### **ADDENDUM NO. 1**

Date: 7/11/2017

**Project: Field Improvements at West Campus High School**

**West Campus High School**  
Synthetic Practice Field & Road Improvements, Inc. 1

Title: FIELD FENCING SECTIONS AND DETAILS		Ref: C1.6.4	
Project: SCUSD WEST CAMPUS HIGH SCHOOL SCIENCE & TECHNOLOGY BUILDING INCREMENT 1		Job No: WCE No.16-171	Sheet No.
		Scale: 1" = 20'-0"	<b>AD1-9</b>
		Date: 7-11-2017

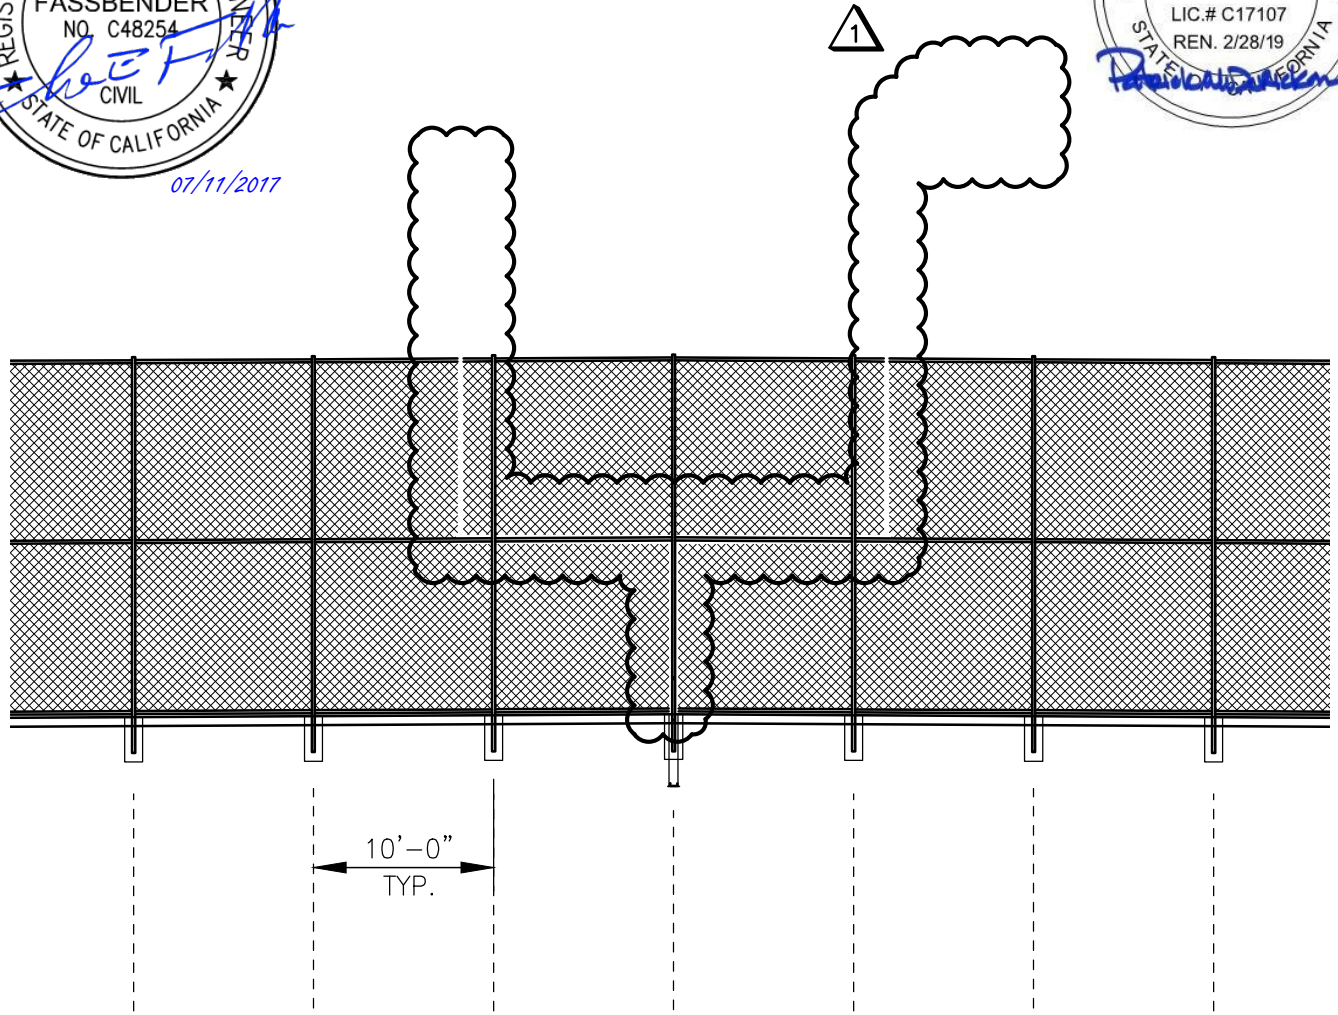
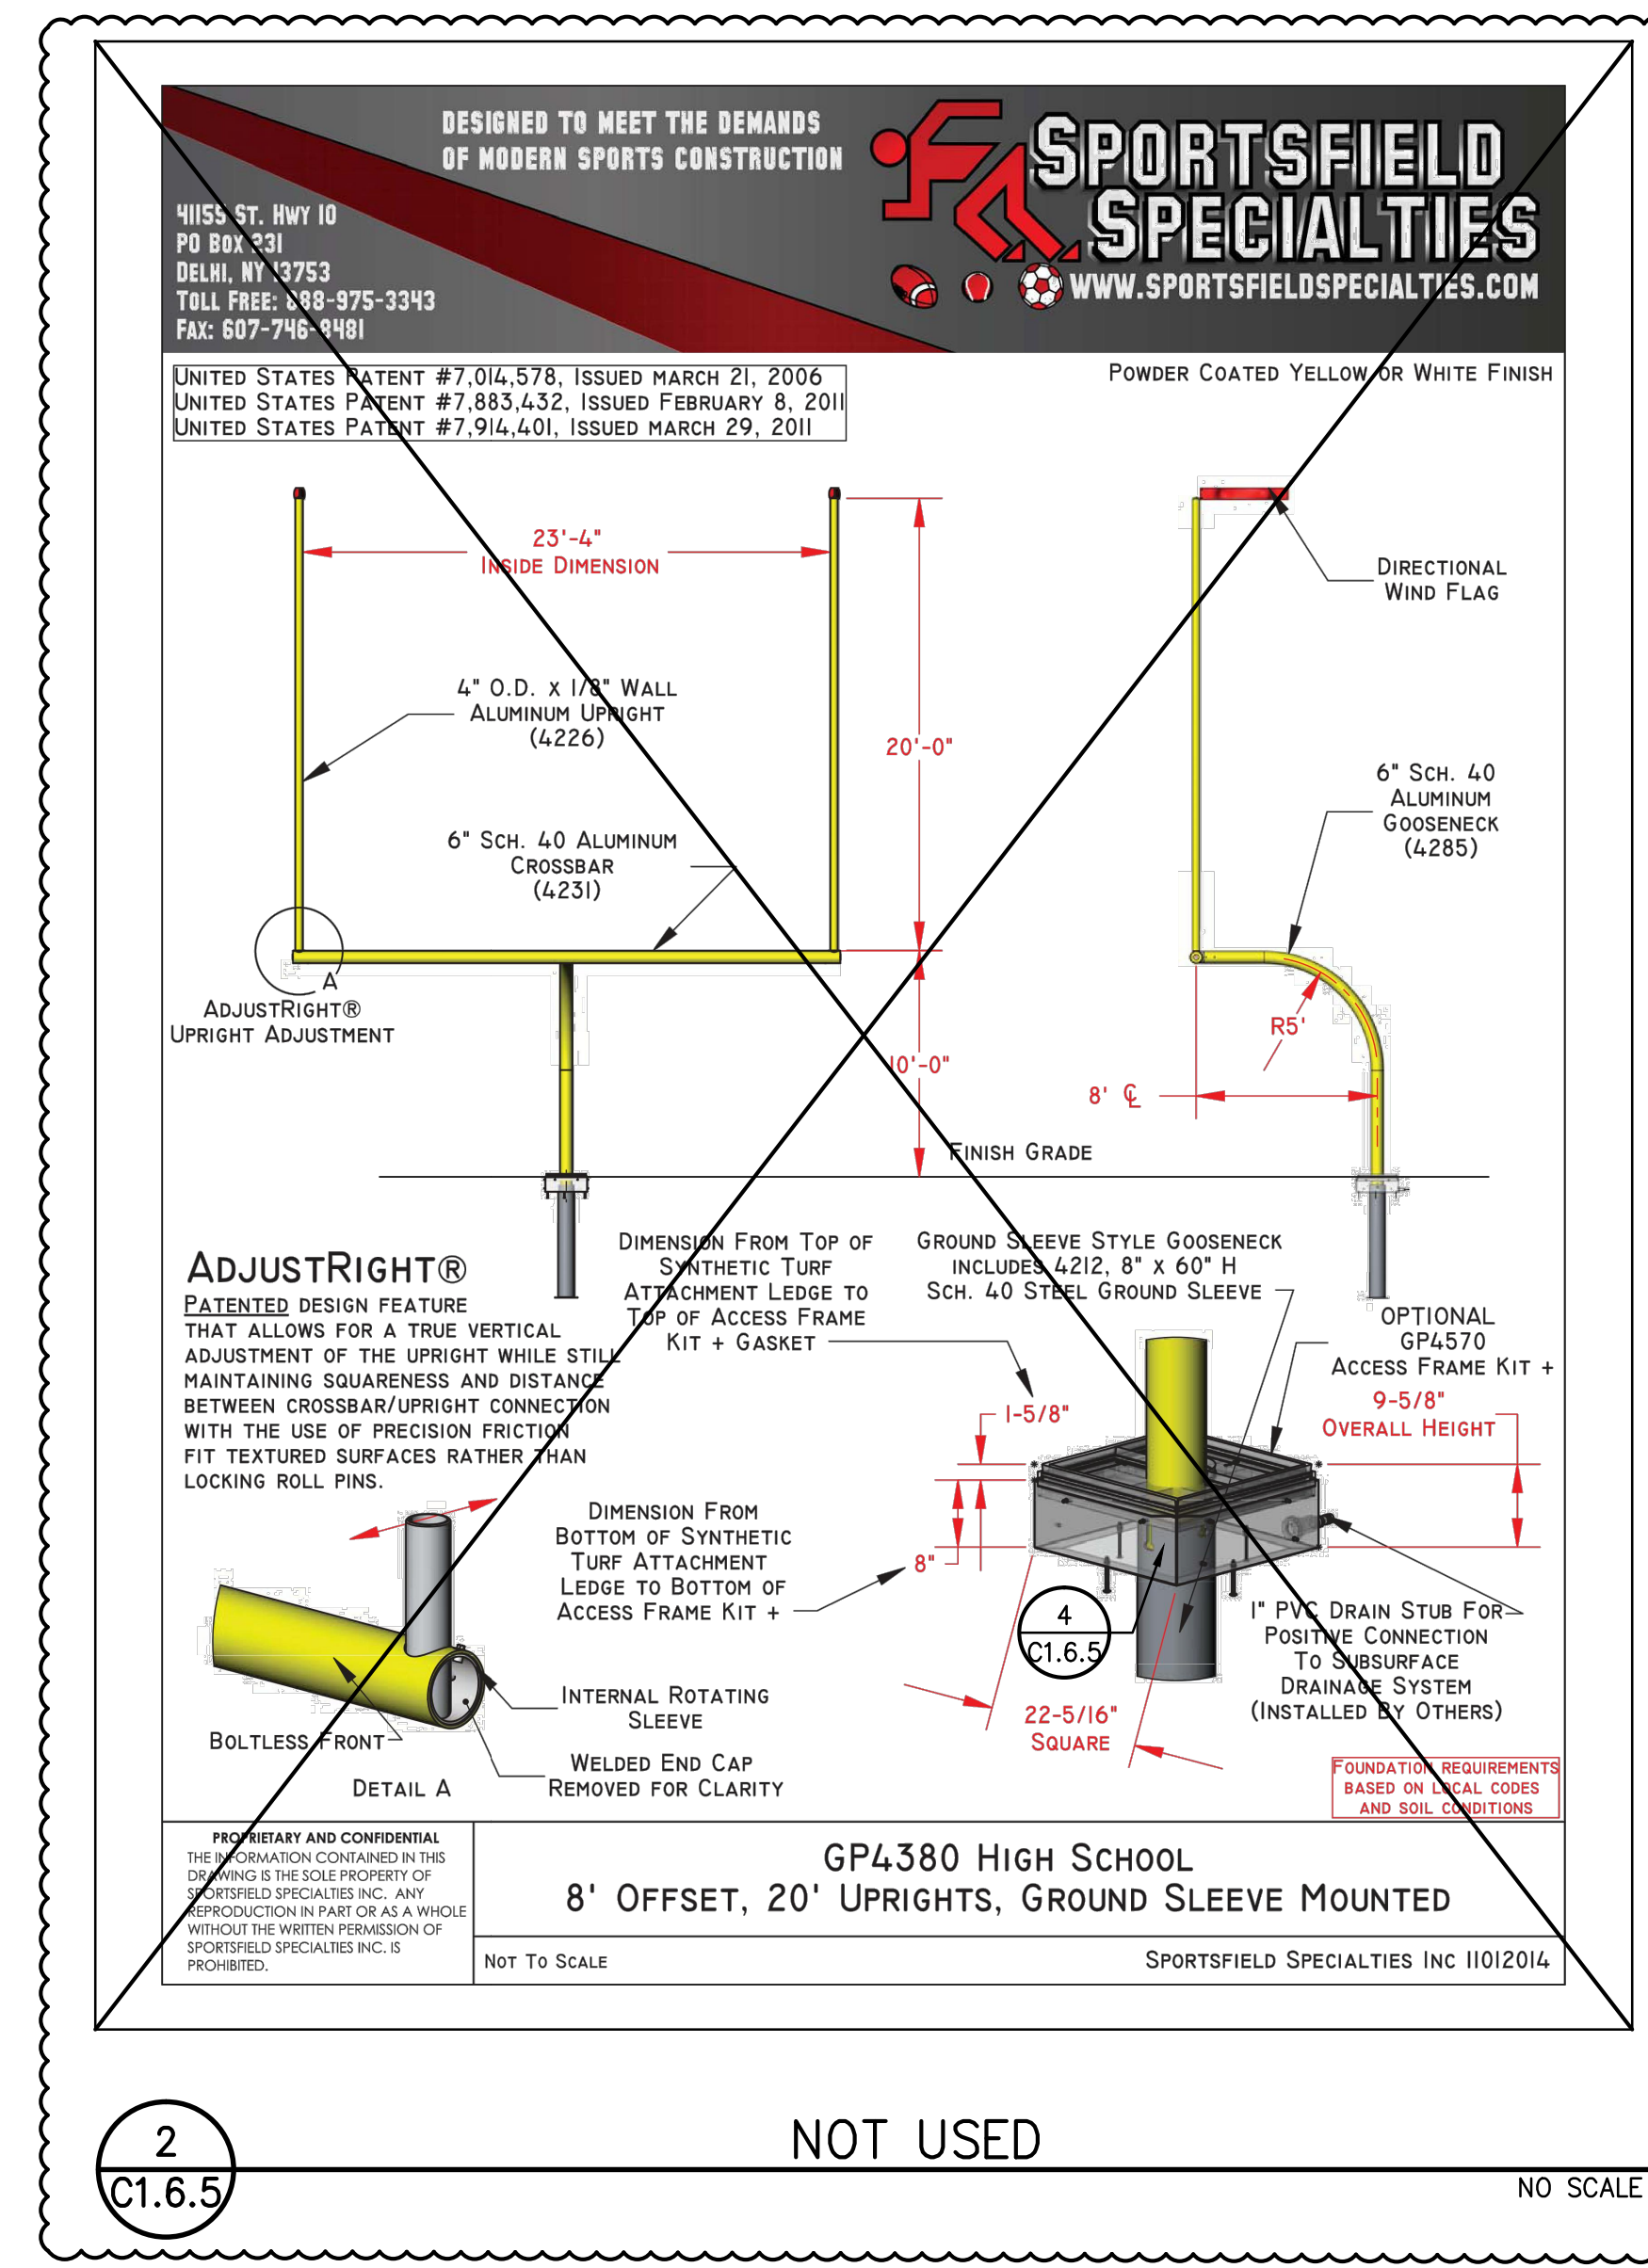
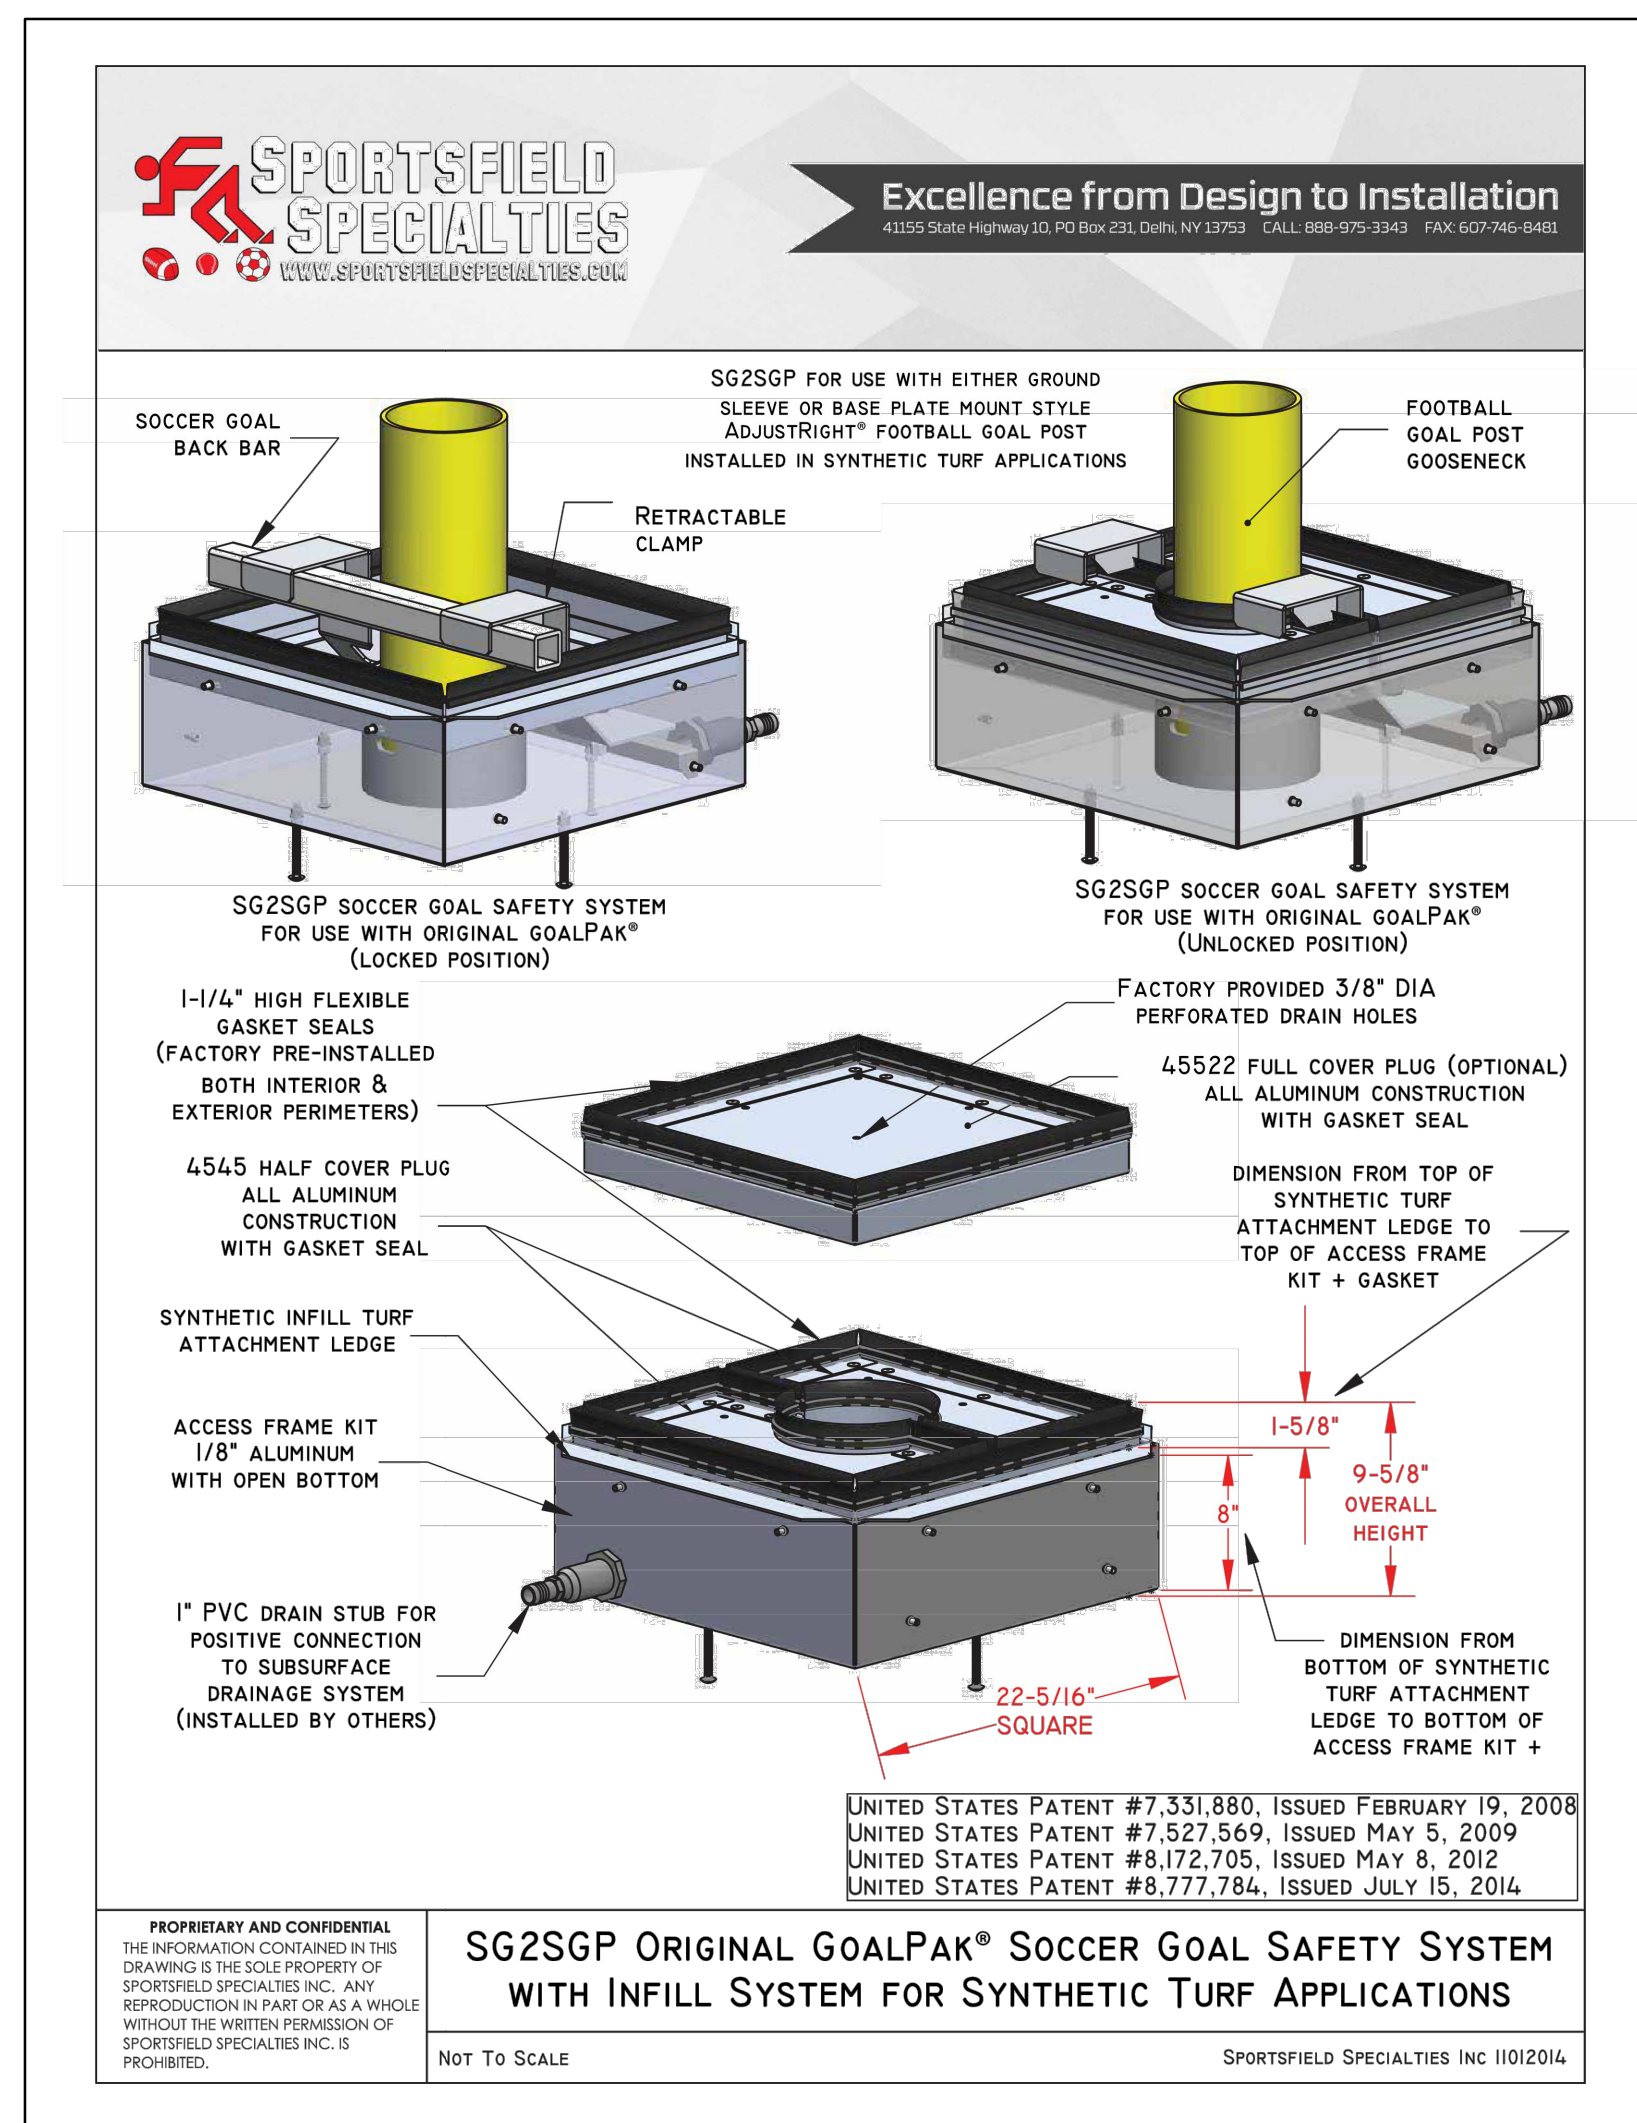
7. AD1-7 FIELD LAYOUT PLAN
  - a. Ground sleeves and soccer lock down to be installed at both goal ends.
8. AD1-8 FIELD FENCING AND EQUIPMENT PLAN
  - b. Only goal sleeves to be installed, goal posts to be provided but not installed.
9. AD1-9 FIELD FENCING SECTIONS AND DETAILS
  - c. Goal post to be provided but not installed.
10. C1.6.5 FIELD EQUIPMENT DETAILS
  - d. Some equipment not used.
11. C1.8.3 DETAILS AND SECTIONS
  - e. Field section detail updated.
